## STAFF REPORT

**REFERENCE:** RM060937 RM060938

**SUBJECT:** **NEW ZEALAND ENERGY LIMITED - REPORT EP09/02/03 -**  
Report prepared for hearing of 9 to 13 February 2009

## Spill Section Changes

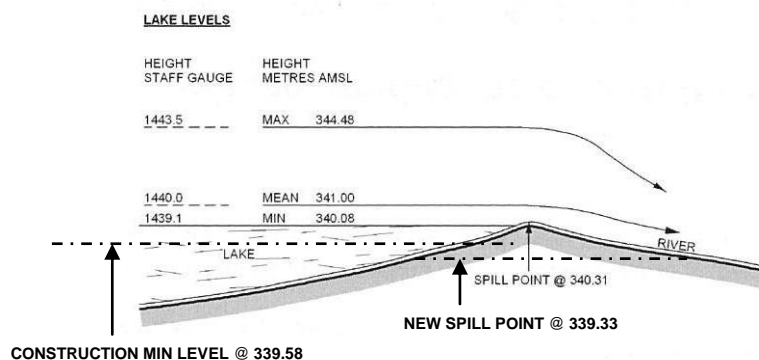
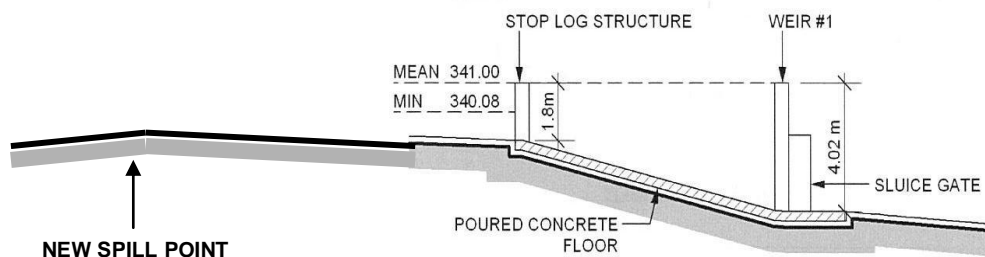
The proposed new spill point at 339.33 metres will be dug to facilitate construction of weirs 2 and 3. On completion of these weirs, the no.1 channel will be excavated to its final level 1 metre below the natural lake minimum spill point. The application provides no explanation for why the lower spill point is necessary.

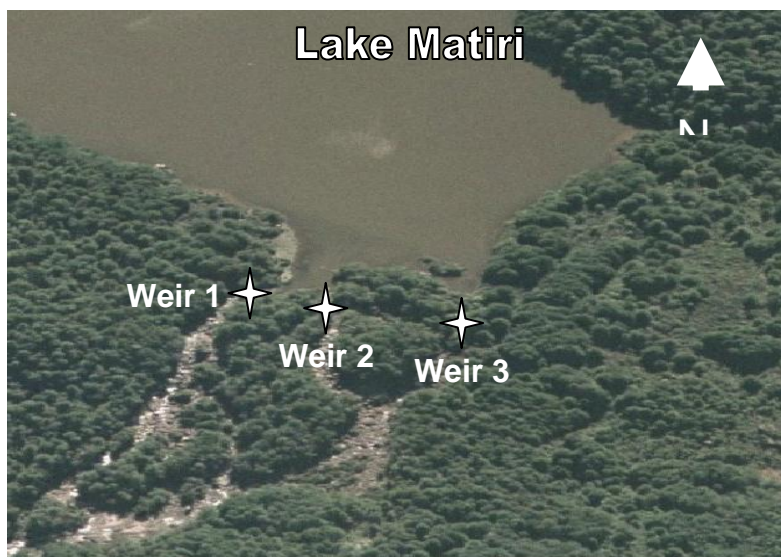
The responses provided are not considered to be complete or in sufficient detail to allow a complete assessment of the application to be made. Until complete information has been provided the potential effects on the environment resulting from this proposal, and ways these effects can be mitigated, cannot be fully determined and assessed.

MWH have been consulted and advise that sediment control curtains will be satisfactory in this area, please see section 6 of our application. Please note also that section 8 of the MWH report discusses the use of form works to contain concrete as it is poured for the structures around the lake.

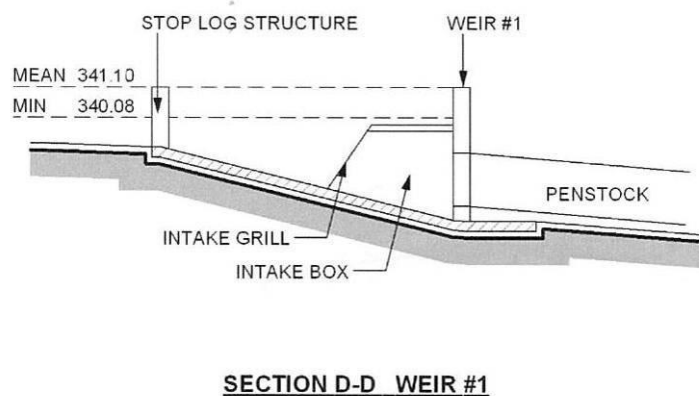
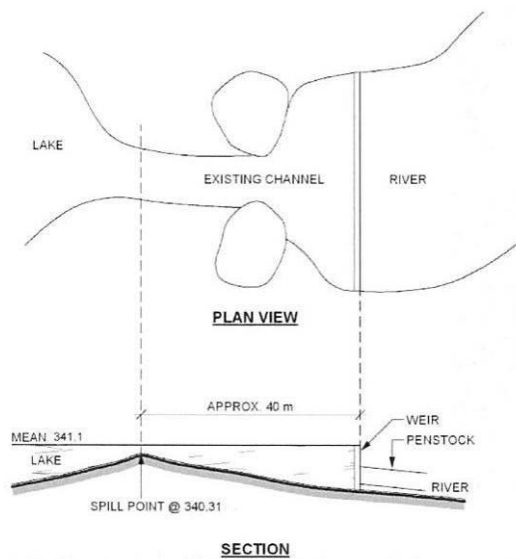
Weirs 2 and 3 will be accessed via the lake edge. The possible adverse effects of this have not been assessed in the application nor have the sediment profiles or lake contours been provided.

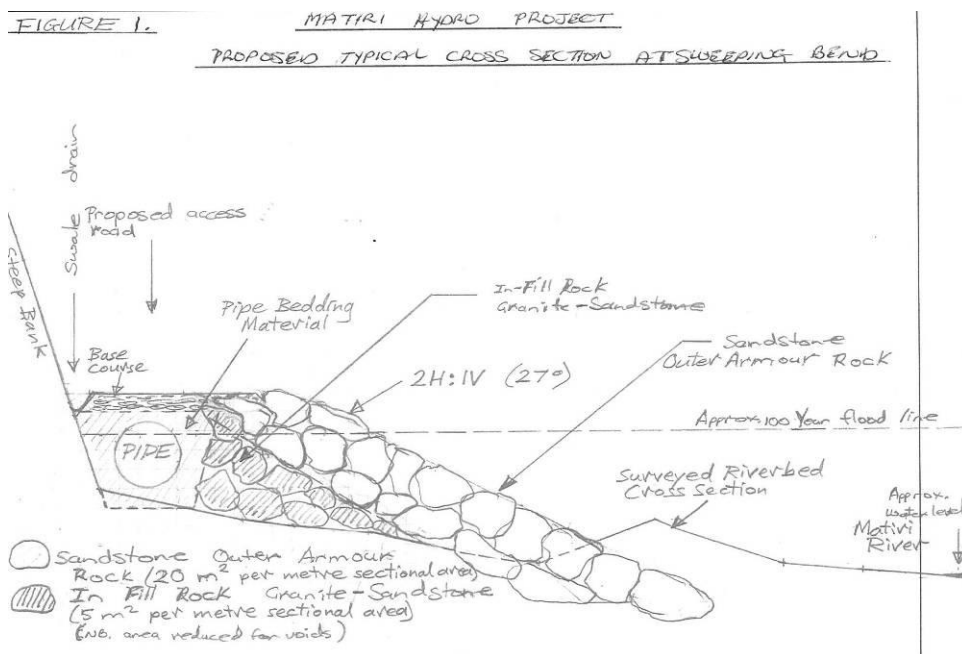
35. Whether the penstock be above a Q100 flood	The penstock may need to be armoured if it interacts with flood flows	Where the penstock isn't buried but exposed to flood flows then armouring will be achieved by appropriate placement of boulders excavated from the site works. It is envisaged that this will likely occur in a short 20mtr section of the penstock. Important to note that exposure

Until this information has been provided the potential effects on the environment resulting from this proposal and ways these effects can be mitigated cannot be determined.

Additional information	Why this information is required	NZEL Reply
		to flood flows does not pose a significant threat to the penstock. As the waters are lake feed, debris likely to be carried in high flows will be minimal. Furthermore, a penstock full of water has a equal or higher density than the flood water itself. The penstock will be fabricated from 10mm plate steel.

Sweeping Bend flood channel as mentioned above in the NZEL reply.

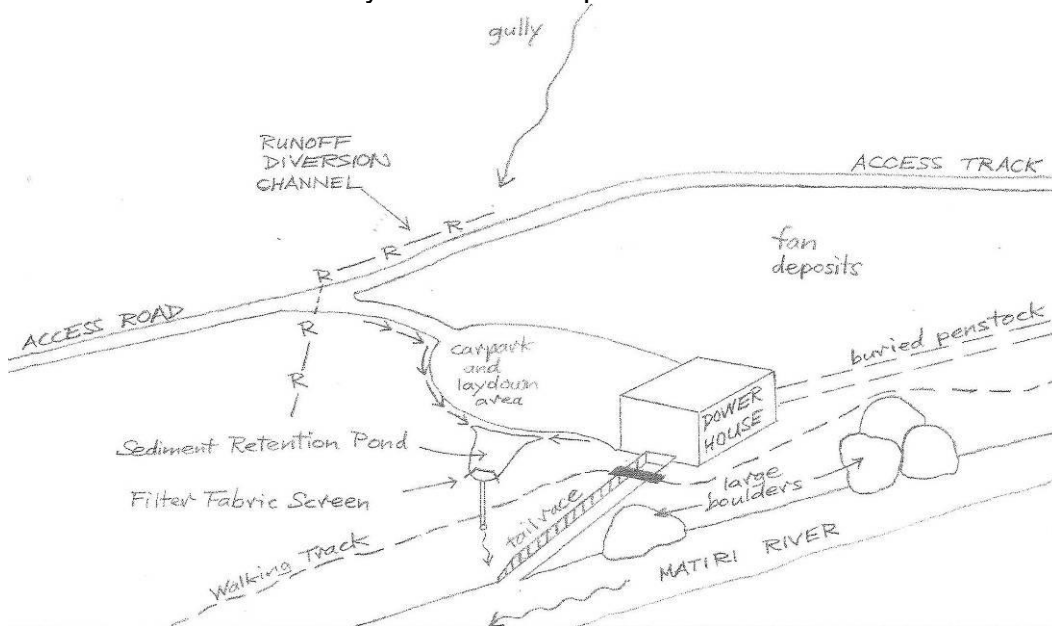
What volume of rock will be required to armour the Penstock?	It is unclear if there is enough rock to undertake this armouring	Refer to section that describes this.
How is it proposed that the base for armouring be undertaken given it is likely to be lower than mean flow level		This is a matter for the contractor to come up with the best technique. In saying that though it may be necessary to move river channel during this section of the works

The sweeping bend looking upstream is shown above. Note the River channel is not hard against the true right bank of the river where the penstock route is proposed. The flood channel can be seen in the bottom right of the image.

Additional information	Why this information is required	NZEL reply
		waterfall then these will be avoided!
Will the machinery be working in the waterway to construct the penstock be in the flowing channel?	Machinery working in the flowing channel is likely to release more sediment.	Machinery will not be required to work directly in the water however from time to time they may need to enter the water course when building the penstock foundations and installing the penstock.
Is it proposed to divert or alter the river channel during construction?	If a diversion is proposed it will need to met the permitted activity rules or be covered by a resource consent	<p>It is not anticipated that the river channel will need to be moved at all unless required to install armoured wall.</p> <p>There exists quite an active channel during high floods at sweeping bend and is no doubt the reason the water level at the sweeping bend does not rise as high as one would expect.</p> <p>An option exists to divert the river flow down this channel during installation of the Penstock and armouring wall around the sweeping bend.</p>

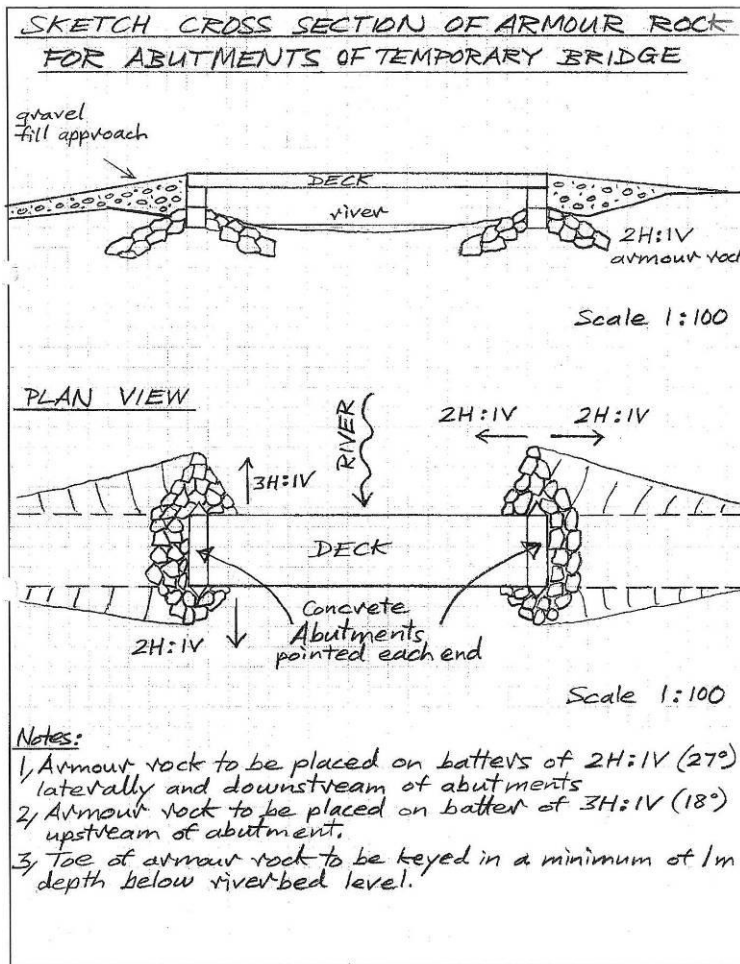
<b>Why this information is required</b>	<b>NZEL reply</b>
The configuration of the discharge point	To determine the possible adverse environmental effects	The conceptual design has a tail race entering the river just below the power station. This will likely be a boxed open concrete culvert section. Discharge level will be at the same level as the natural river level.
How will the water from the powerhouse be conveyed to the discharge point?		Yes, as above

<b>Why this information is required</b>	<b>NZEL reply</b>
What materials will be used to construct the tailrace structures?		Yes, as above
Will the discharge point of the tailrace into the river be armoured?		Rocks will be placed around the river bank and concrete culvert to protect the structure and river bank.
Will there be any energy dissipating structure installed before the tailrace is discharged into the river?		No, this will not be required as the draft tube on the turbine will exit lower than the river level.
How will a sediment curtain be used?		This is a matter for the contractor to manage so that they minimise or avoid sediment entering the river whilst undertaking these works.

FIGURE 3 MATIRI HYDRO PROJECT  
PROPOSED TYPICAL CROSS SECTION OF PENSTOCK  
DOWNSTREAM OF SWEEPING BEND.

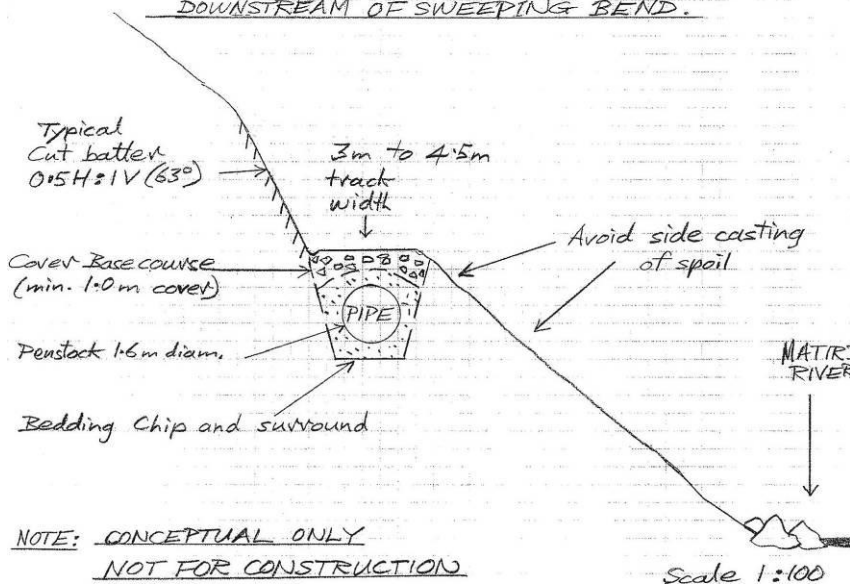
NZEL propose to place the penstock in the ground downstream of sweeping bend and this will generate significant earthworks. The following figure shows the typical cross section downstream of sweeping bend where the penstock is buried.
